**PCN#20150708003  
New trays for Select Devices  
Final Change Notification**

**Date:** 7/20/2015  
**To:** MOUSER PCN

#### CJL and AAF tray change

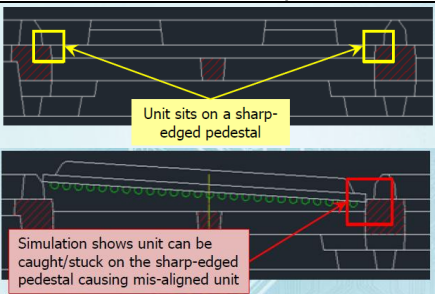
Texas Instruments is pleased to announce the qualification of a new improved tray for the devices listed below. A comparison summary is below:

What	From	To
Stock #/Supplier	4207771(CJL)/Kostat & 4218140(AAF)/Daewon	4221336/Daewon
Weight	110g	168g
Surface Resisitivity	10 exp 7/10 exp 6	10 exp 5
Temperature Rating	150C	150C
Color	Black	Black
Raw Material	MSPU/MPPPO	MPPPO
Thickness	7.62	12.19
Pocket Design	Pedestal/Slope	Slope
Tray Design	 <p>Unit sits on a sharp-edged pedestal</p> <p>Simulation shows unit can be caught/stuck on the sharp-edged pedestal causing mis-aligned unit</p>	 <p>No pedestal design on pocket</p>
Tray Fence	 <p><b>LIVE BUG</b>      <b>DEAD BUG</b></p> <p>Interlock on current tray is cross-design – can hit unit at corner if mis-aligned</p>	 <p><b>LIVE BUG</b>      <b>DEAD BUG</b></p> <p>Proposed tray has no interlock both on top and bottom pocket</p>

ITEMS DESCRIPTION	Symbol	4207771-0001 (Kostat - CJL)			4218140-0001 (Daewon - AAF)			4221336-0001 (Daewon)		
		DIM	Upper Limits	Lower Limits	DIM	Upper Limits	Lower Limits	DIM	Upper Limits	Lower Limits
Overall Length	L	322.6	322.85	322.35	322.6	322.85	322.35	322.6	322.85	322.35
Layout Length	A	315.0	315.25	314.75	315.0	315.25	314.75	315.0	315.25	314.75
Layout Width	B	135.9	136.15	135.65	135.9	136.15	135.65	135.9	136.15	135.65
Layout Length on Top Stack frame	A1	311.15	311.40	311.02	311.15	311.40	311.02	311.15	311.40	311.02
Layout Width on Top Stack frame	B1	132.08	132.33	131.95	132.08	132.33	131.95	132.08	132.33	131.95
Layout Length on Bottom Stack frame	A2	311.66	311.91	311.53	311.66	311.91	311.53	311.66	311.91	311.53
Layout Width on Bottom Stack frame	B2	132.59	132.84	132.46	132.59	132.84	132.46	132.59	132.84	132.46
End Tab Length	n/a	92.1	92.35	91.85	92.1	92.35	91.85	92.1	92.35	91.85
Overall Height	K	7.62	7.75	7.49	7.62	7.75	7.49	12.19	12.32	12.06

Stack Height	K1	1.27	1.40	1.14	1.27	1.40	1.14	2.03	2.16	1.90
Tray Matrix No.		4x10			4x10			4x10		
Pitch M	M	24.15	24.28	24.02	24.15	24.28	24.02	24.15	24.28	24.02
Pitch M3	M3	29.20	29.33	29.07	29.20	29.33	29.07	29.20	29.33	29.07
Pitch M1	M1	26.10	26.23	25.97	26.10	26.23	25.97	26.10	26.23	25.97
Pitch M2	M2	29.20	29.33	29.07	29.20	29.33	29.07	29.20	29.33	29.07
Package seating height (Top)	Ks	2.00	2.13	1.87	1.80	1.90	1.70	2.92	3.05	2.79
Package seating height (Bottom)	Kb	1.56	1.69	1.43	1.30	1.40	1.20	1.5	1.63	1.37

Eliminate tray vs unit protrusion and tray standardization
